**ADDENDUM NO.:** 003

**IFB NO.:** 725

Description: Furnish, Deliver & Install Audio

Project: CUNY School of Labor and Urban

There are no Audio Visual Drawings. CUNY School of Labor and Urban Studies 14<sup>th</sup> Floor Furniture Plan dated 3/3/22 has been provided.

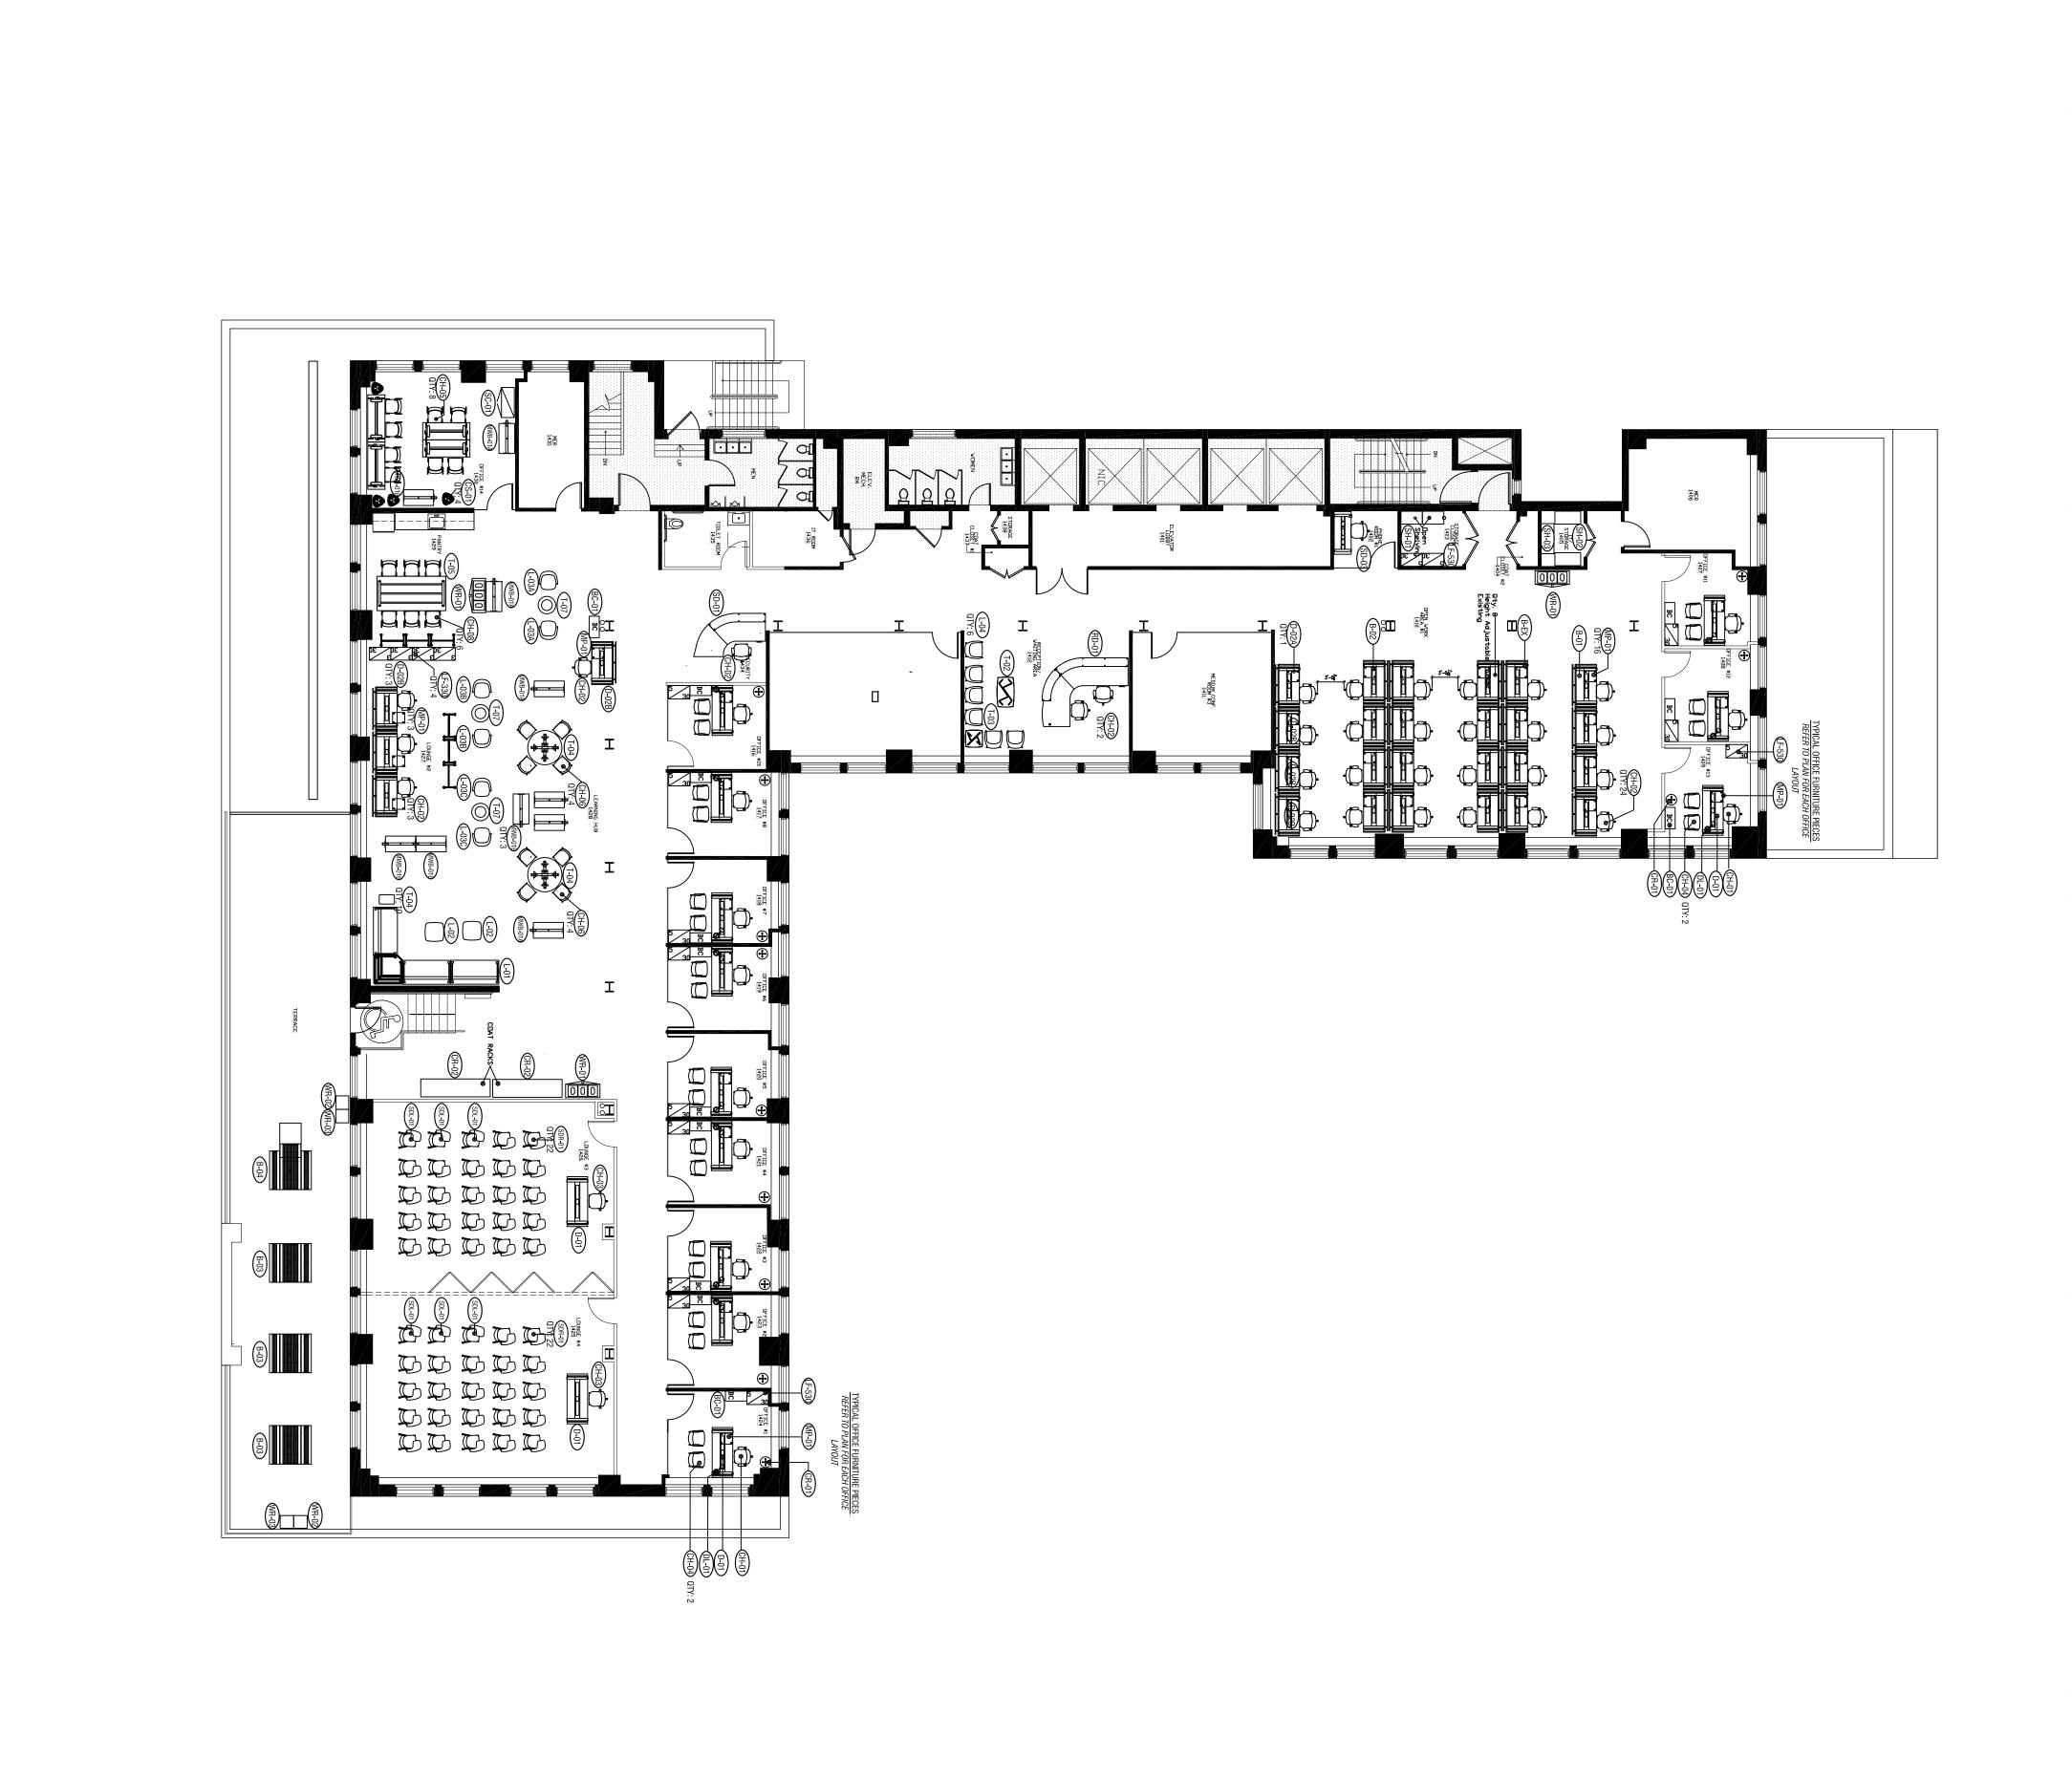
- 10A. Correct, list given was for another room since the layout of 14 changed.
- 11Q. Can you provide a floor plan of the room showing where the future divisible wall will be?

- 12Q. The scope of work handed out during the walk-through says, "Wall plates should accommodate the appropriate connections for the podium and carts to be moved" and that the cart-mounted displays should be "...able to be moved...to designated locations in the room". Can you provide a floor plan of the room showing the requested locations of connection plates and/or the designated locations within the room where you'd like the carts to be able to be used?

- 11A. Attachment C: Scope of Work and Site Logistics is amended to include The CUNY School of Labor and Urban Studies 14th Floor Furniture Plan. A revised version of Attachment C to the Notice and Information for Bidders is included as part of this Addendum.

- 12A. Wall plates should be in front, back and side wall three areas to connect the podiums or carts.
